**FOSTORIA SPLASHPAD
ADA RESTROOM FACILITY
AND PUMP HOUSE**

KLEINFELDER JOB NO. 24001561.002A

ADDENDUM NO. 2

March 26, 2024

Client: CITY OF FOSTORIA, OH
Project: FOSTORIA SPLASHPAD
Drawing: Existing Conditions Plan
Scale: As indicated
Date: 2/5/2023
Job No.: 24001561.002A
Designed by: RDT/CWG
Drawn by: RDT/CWG
Checked by: MJP/DRS
Approved by:
Status:
REVISIONS table with columns for No., Description, Date.

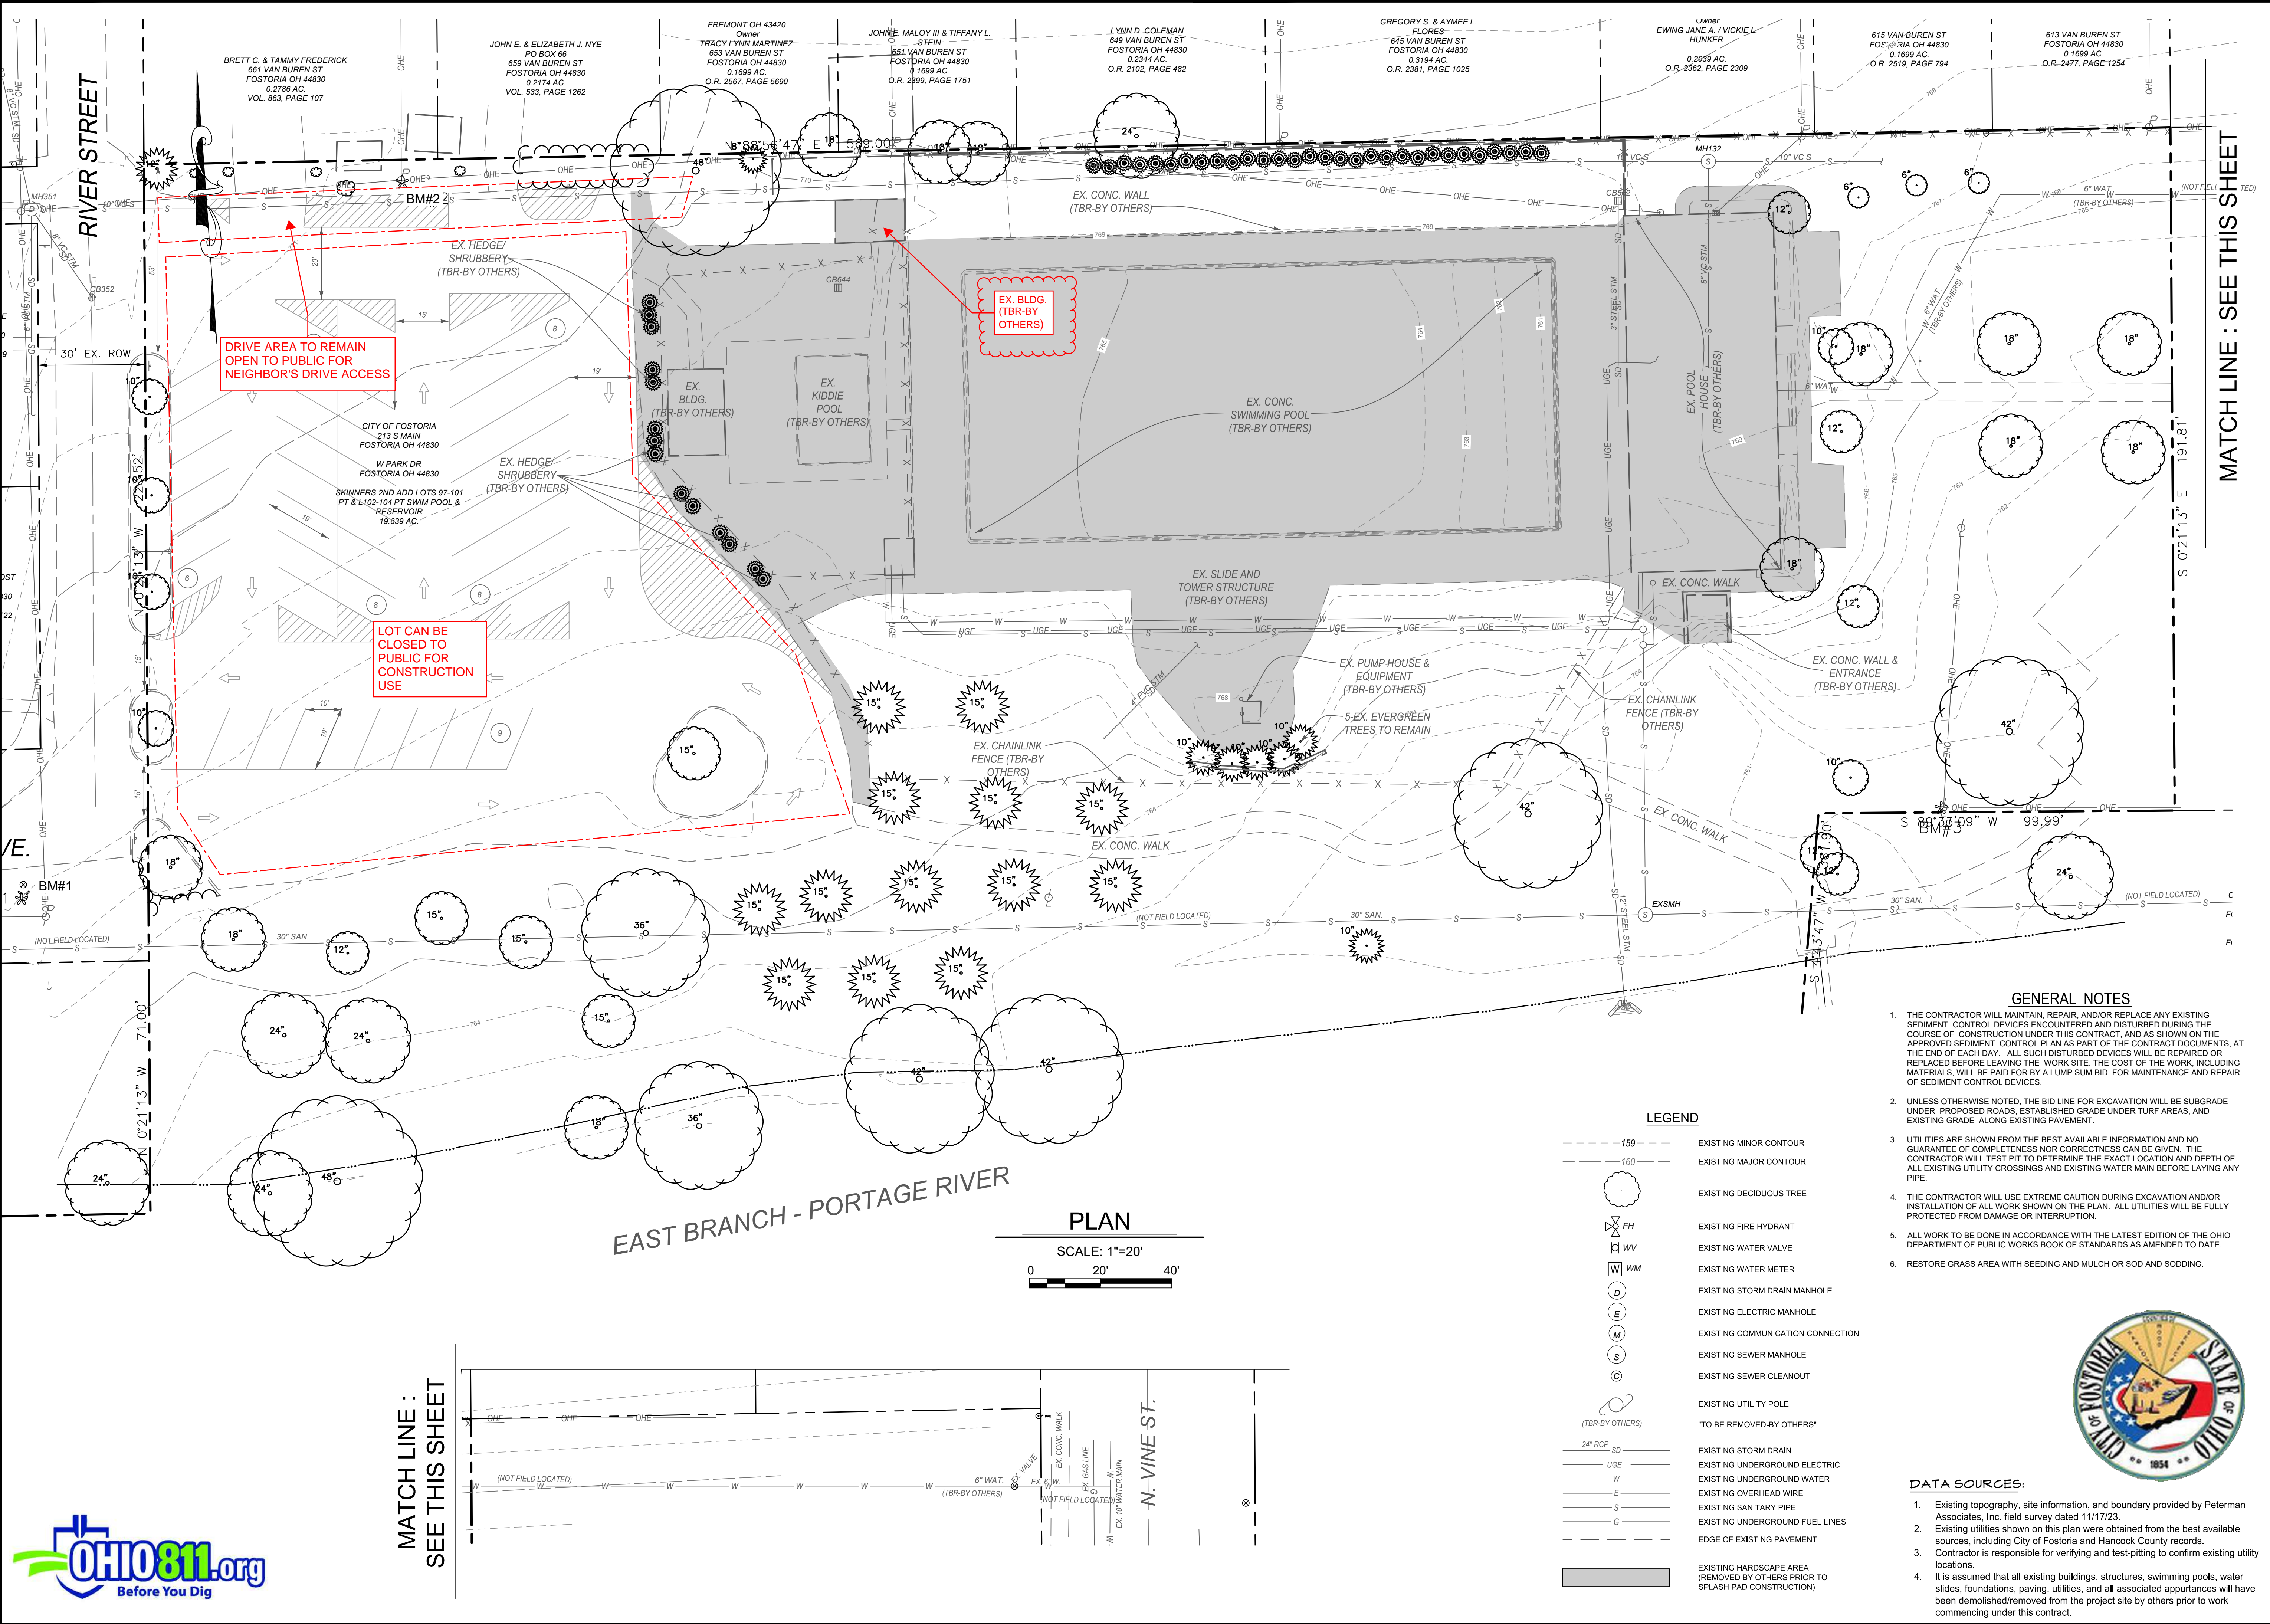
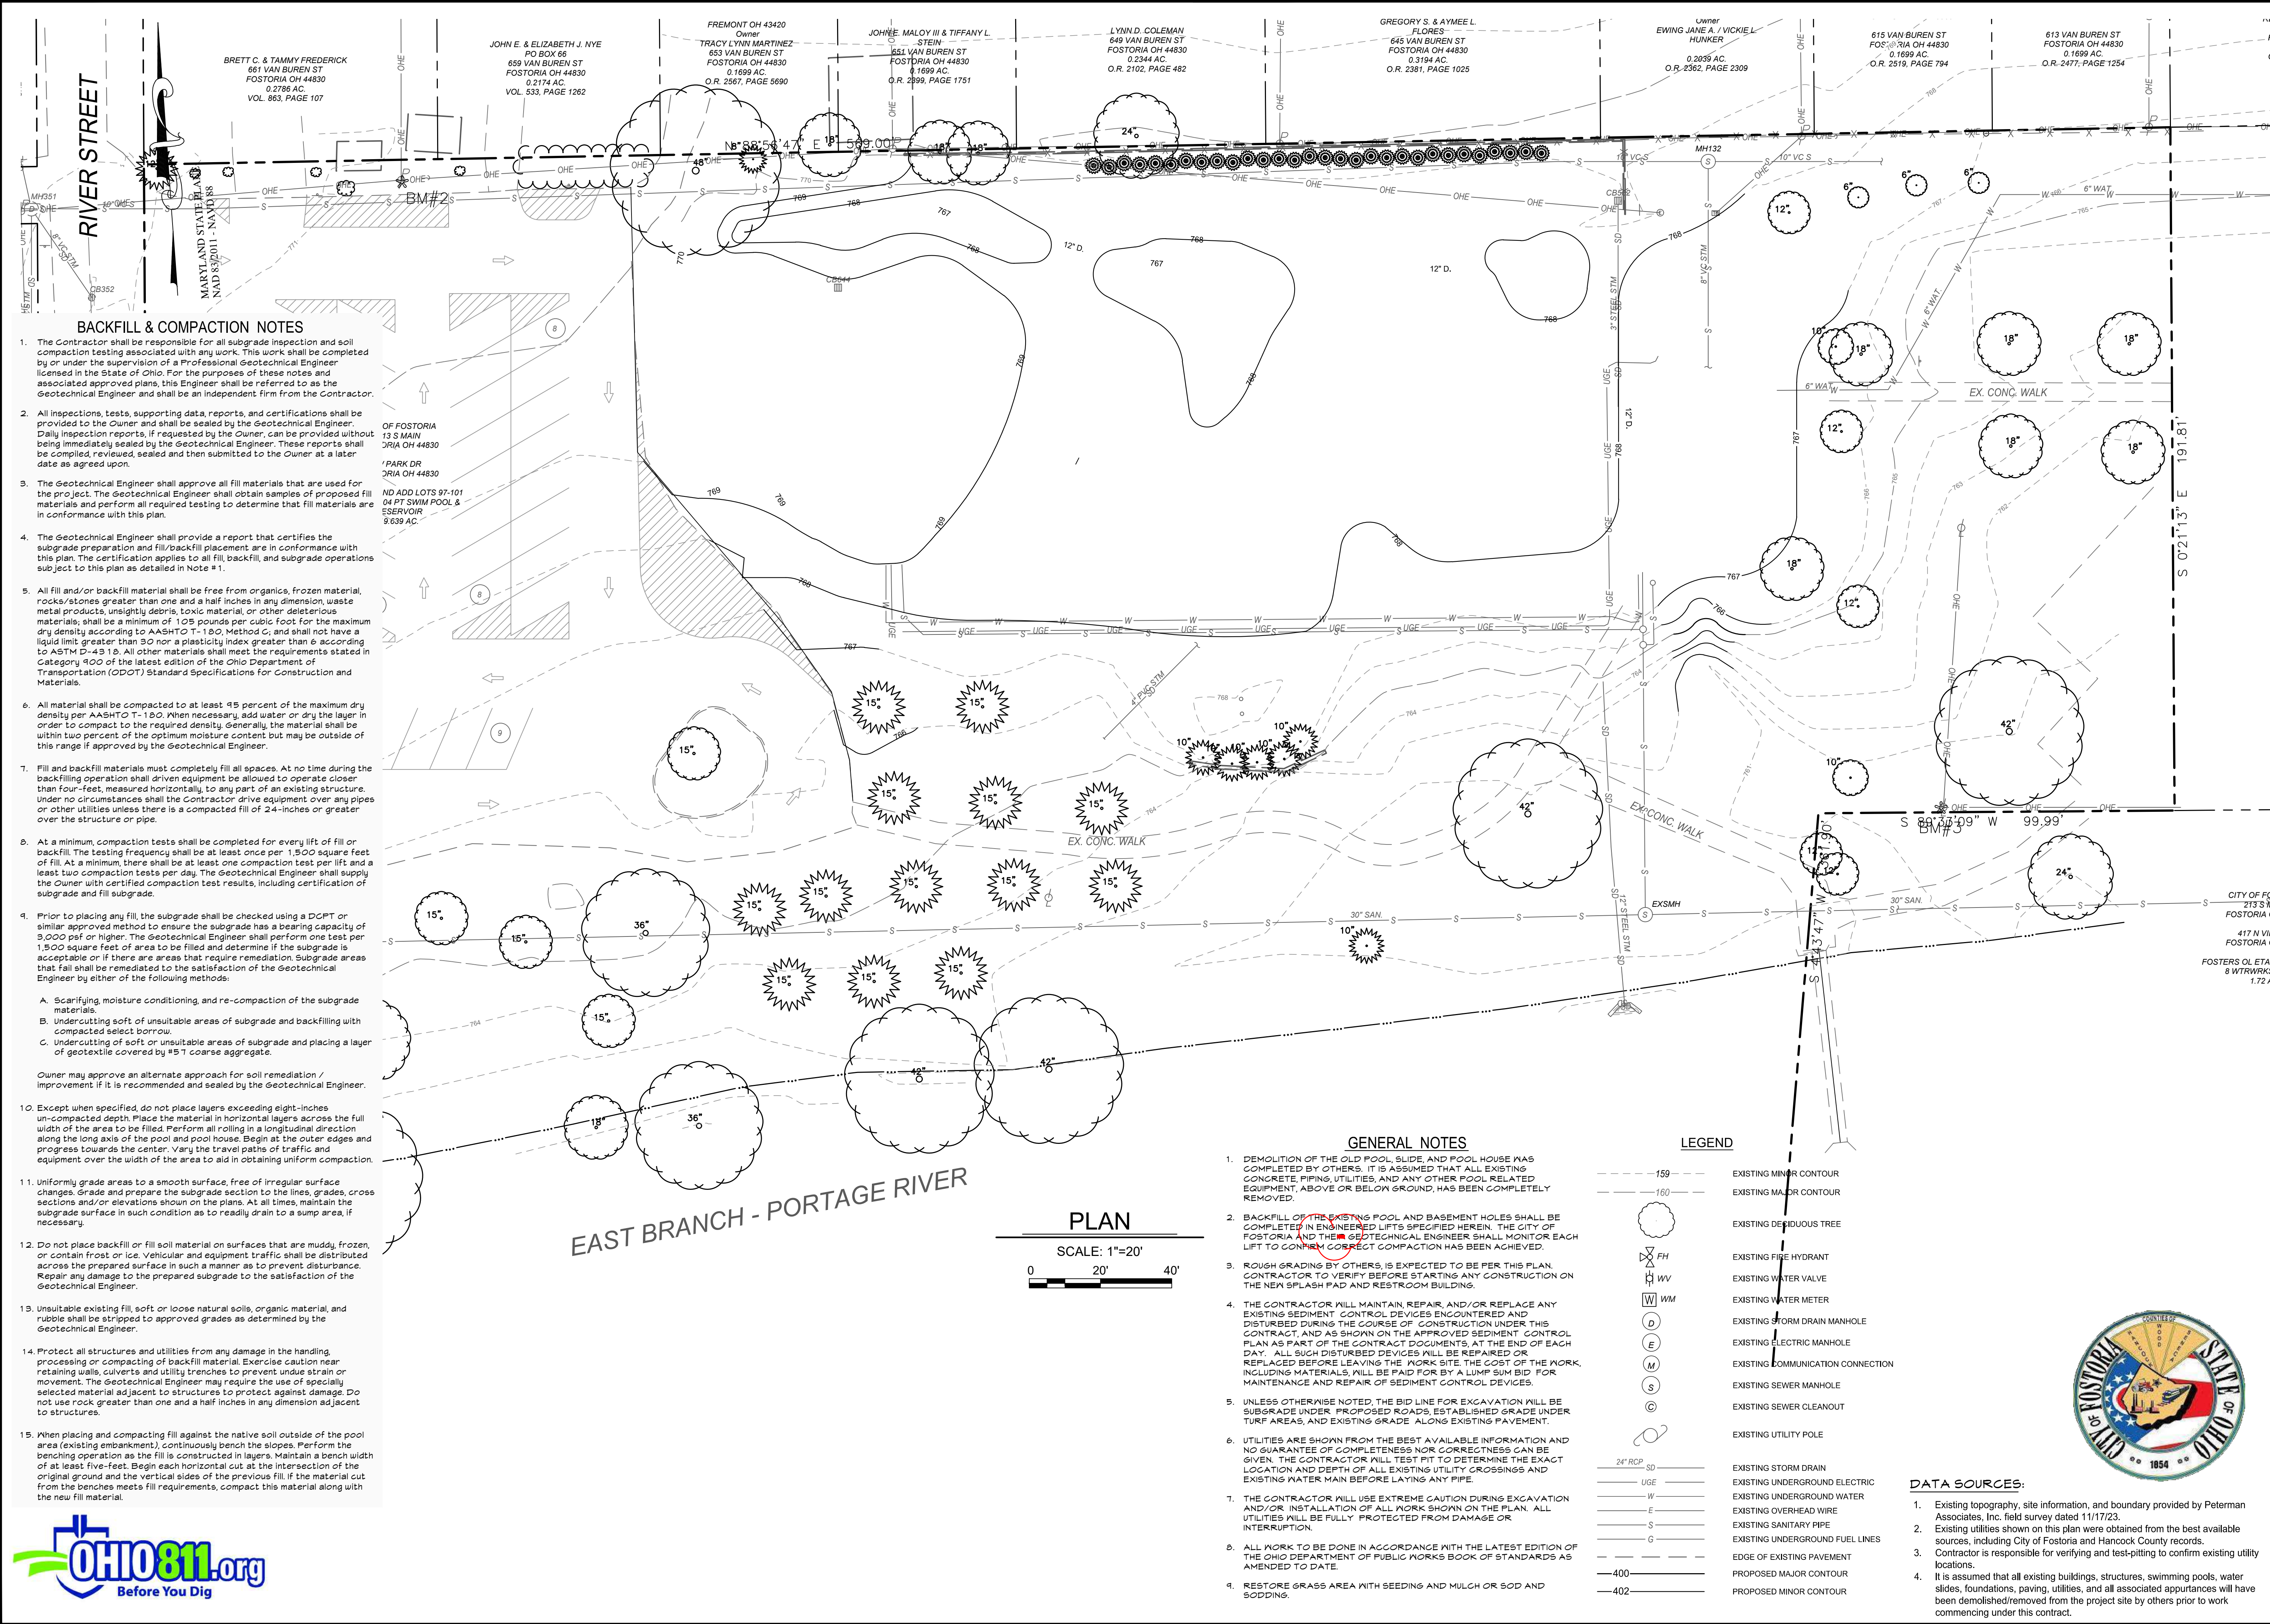
2. Sheet C-01 (reissued herein)
 - A. ADDED note indication existing concession building is to be removed by Others.
 - B. ADDED note indicating limits of existing parking lot closure for construction.

- C. ADDED note indicating existing drive area to be left open for public access to housing and existing driveways on north side of the project.
3. Sheet C-02 (reissued herein)
